WORLDSID-5TH SHOULDER & PELVIS UPDATE

Sept 19, 2012

Background: Photos

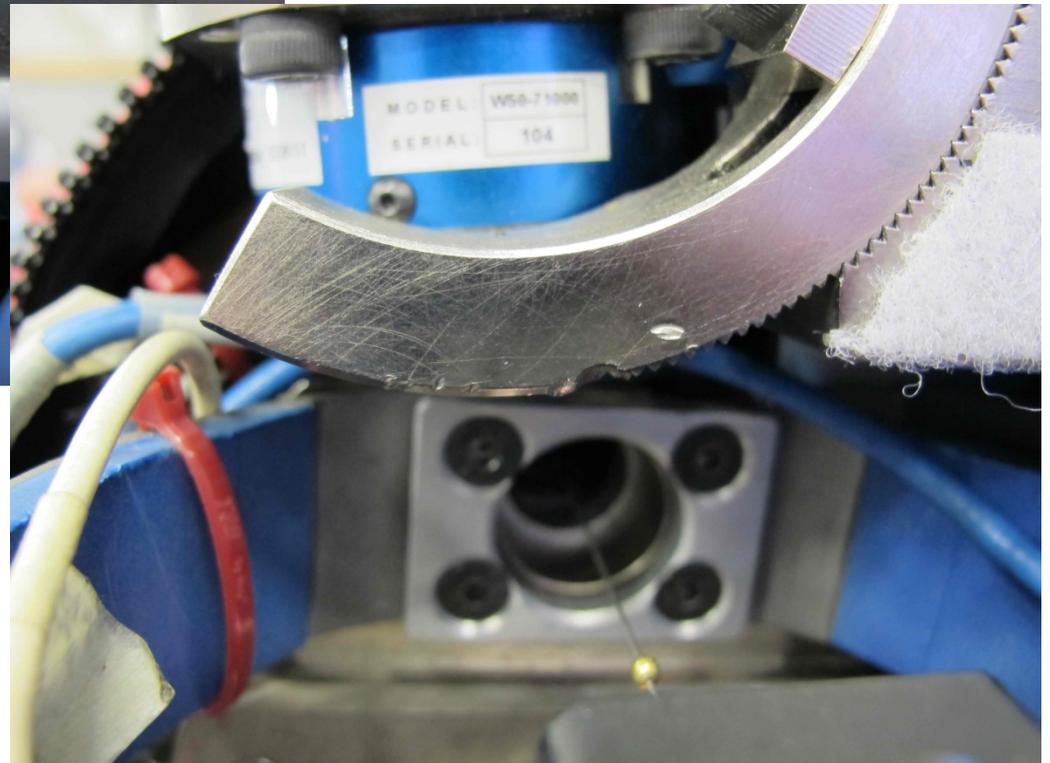
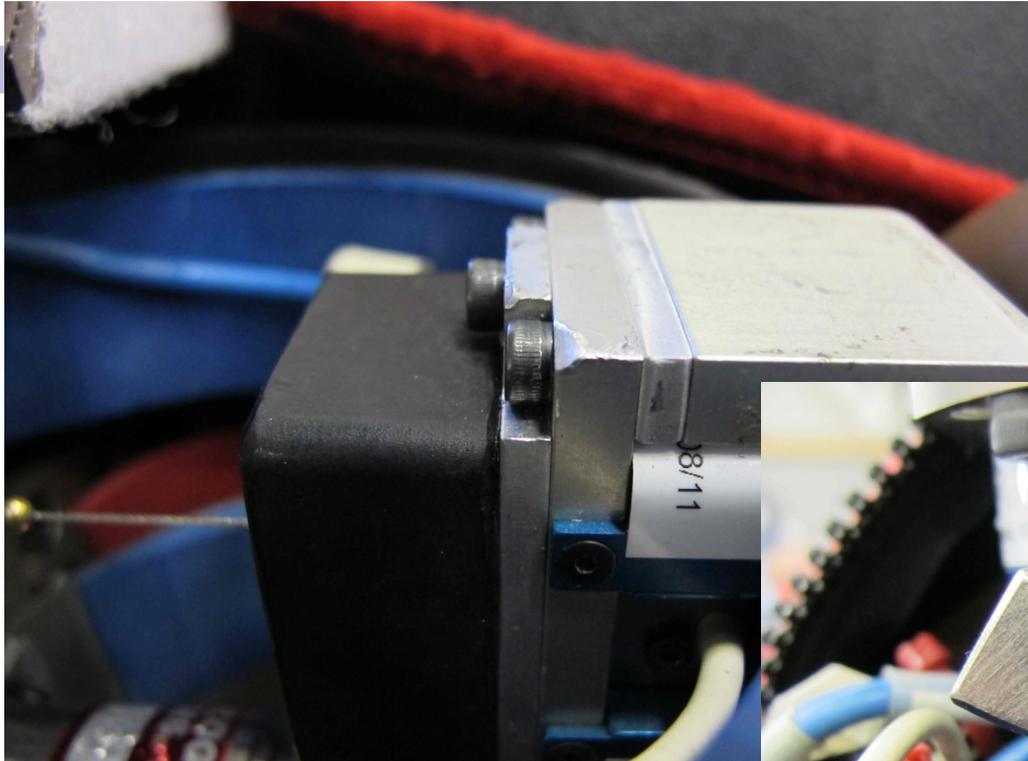
- TRL reported shoulder contacts in their testing at around 45 mm of displacement with upward motion
- Transport Canada provided photographic evidence of contacts

Requirements

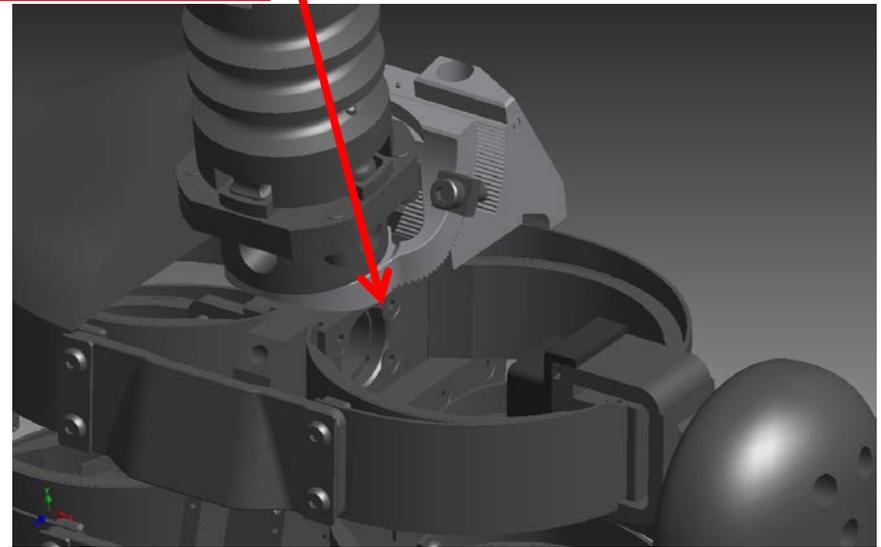
- ***Displacement: 70 mm***
 - *hard contact ok*
- Remove bumper protecting string pot attachment ok
- Lower neck load requirement
 - Absolute Minimum
 - ▶ $M_x = 105 \text{ Nm}$ combined with $F_y = 1060 \text{ N}$
 - Target (goal)
 - ▶ **$M_x = 210 \text{ Nm}$ combined with $F_y = 2200 \text{ N}$ (100% overload)**
 - Use Same for M_y & F_x

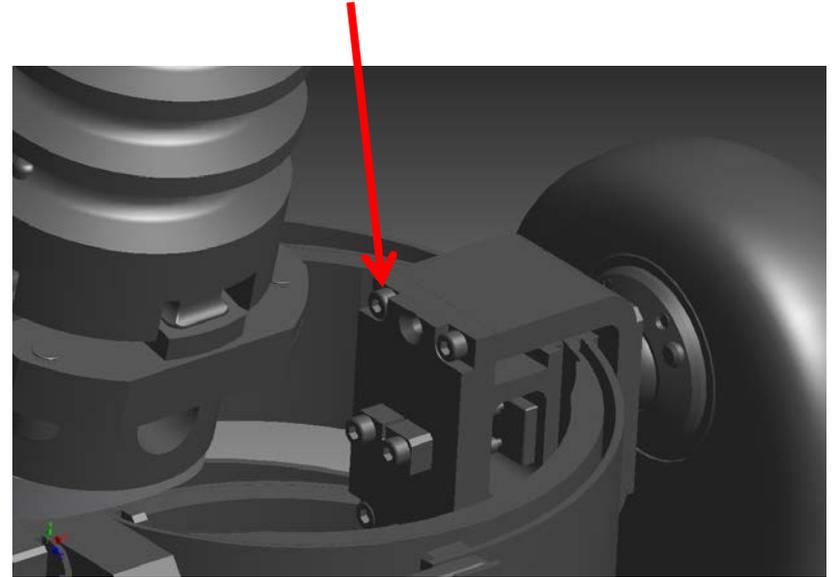
- Determine if the shoulder load cell can be modified to use FHCS to attach to rib clevis & mount string pot string holder directly to load cell instead of interface plate. If so, the interface plate will be eliminated.
- Eliminate the big rubber stop on the inside of the shoulder rib.

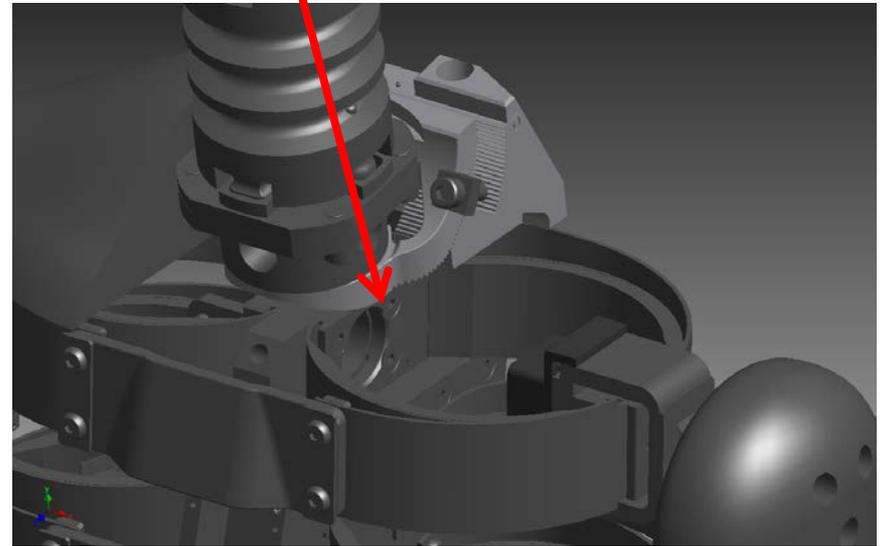
- Determine if the WS neck load cell (upper & lower) can be modified (including existing load cells) to use a pigtail to connector instead of a connector on the load cell. If so, we will try to determine a length that would work for upper & lower WS 5 & 50 locations so that one load cell can do all.

Cut back upper and lower neck brackets as much as possible

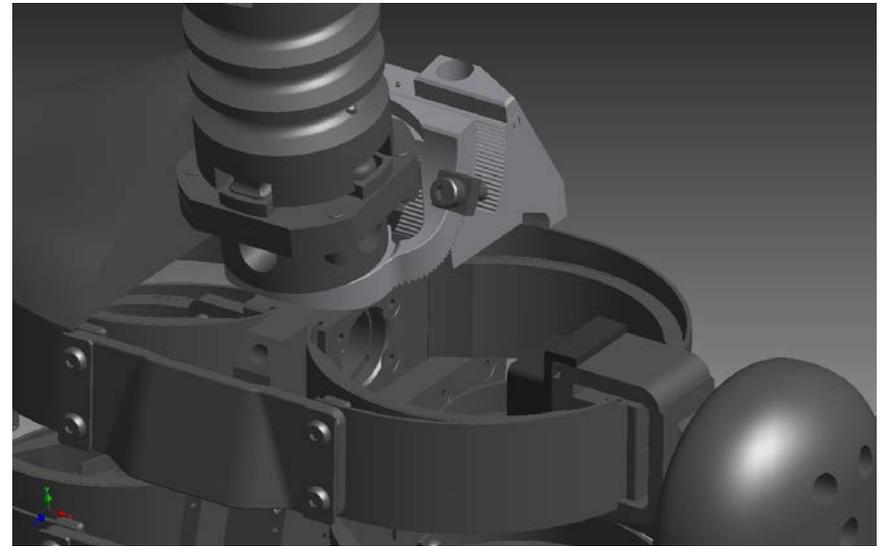
- Redesign the upper and lower neck brackets to give 70+ mm clearance for rib travel. To do this we will explore using a slot in the upper neck bracket for the load cell cables to go through.
- Hit minimum strength targets shown in presentation in red.
- Readjust other parts to maintain total thorax mass.

Flipped lumbar mounting bracket

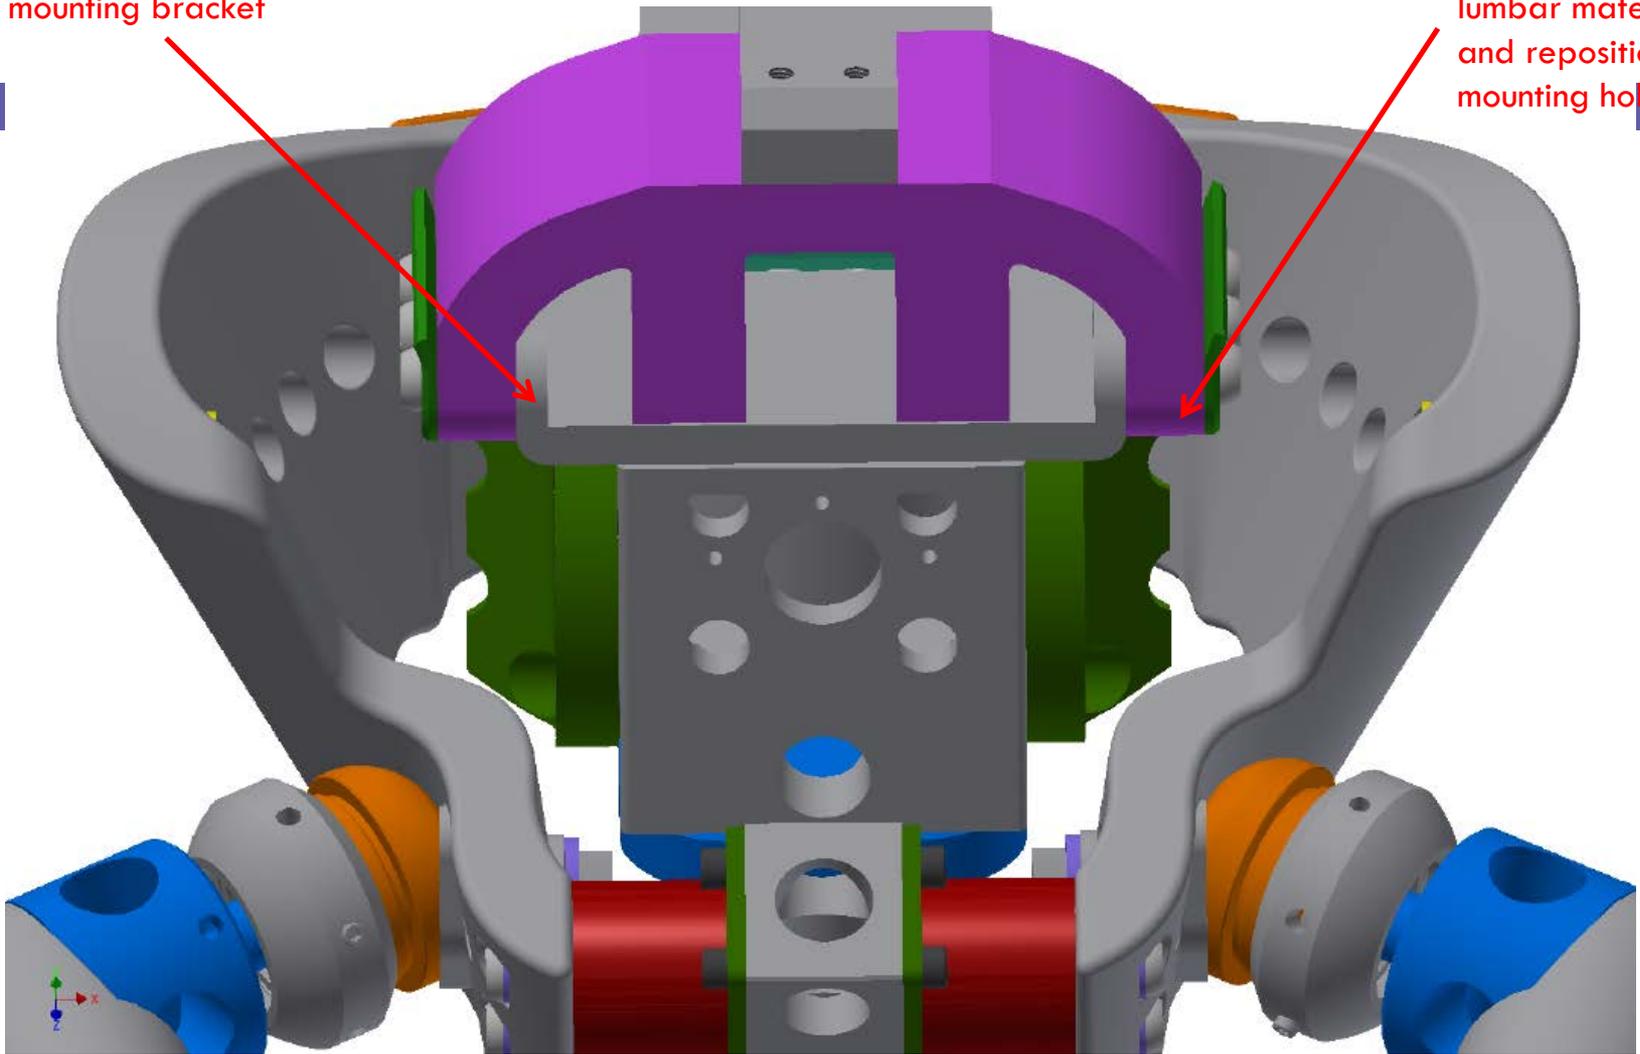
VRTC modifications were tried but did not eliminate the issue

Removed material from iliac

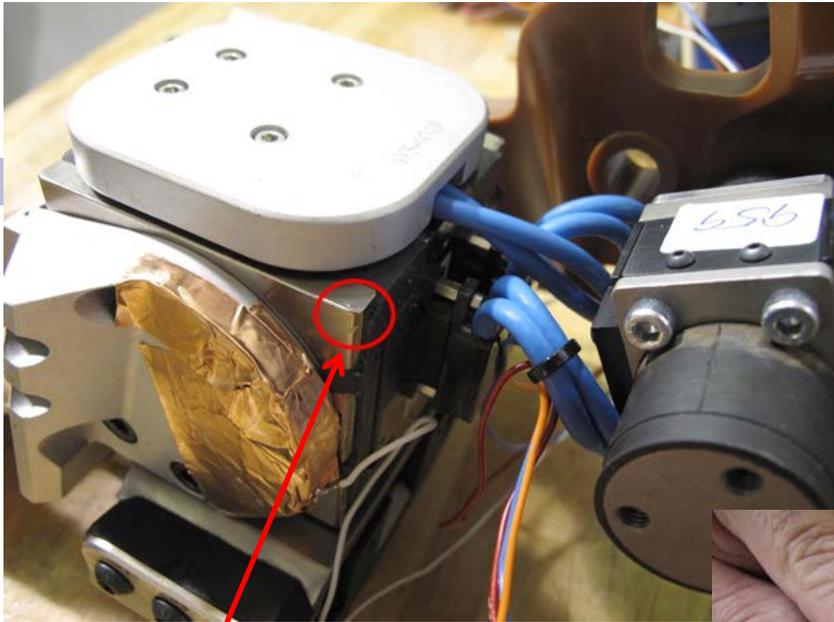
VRTC removed some material from the iliac to provide additional space.

Point of contact on pelvic wing

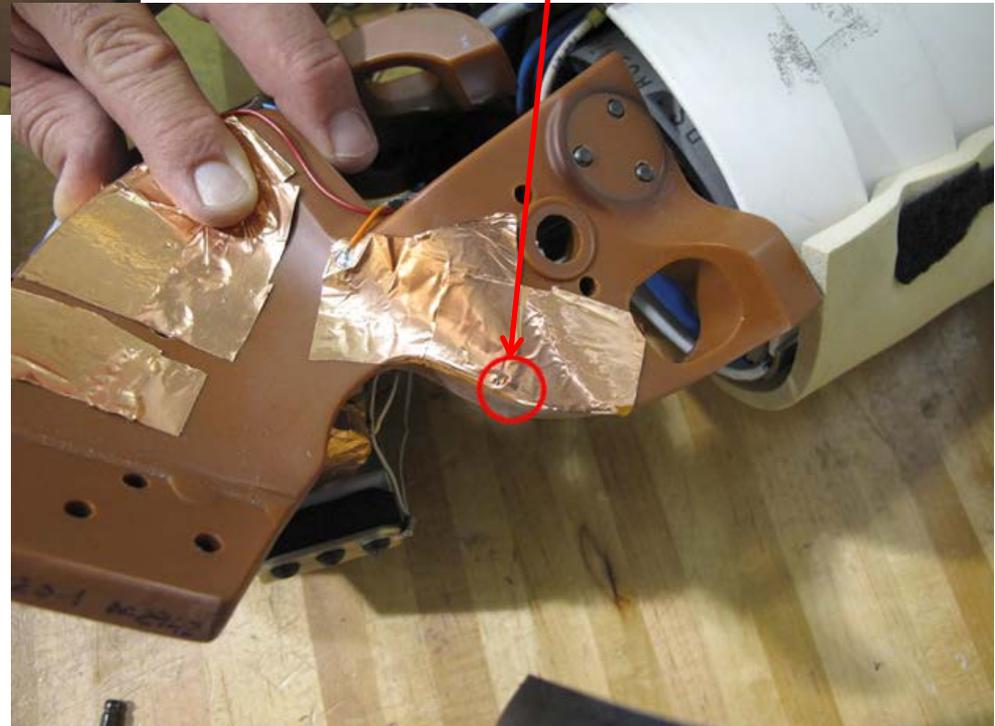
After modifying the pelvis, VRTC still observed minor contact during pelvis impactor tests conducted at 6 m/s (cert test speed is 6.7 m/s)
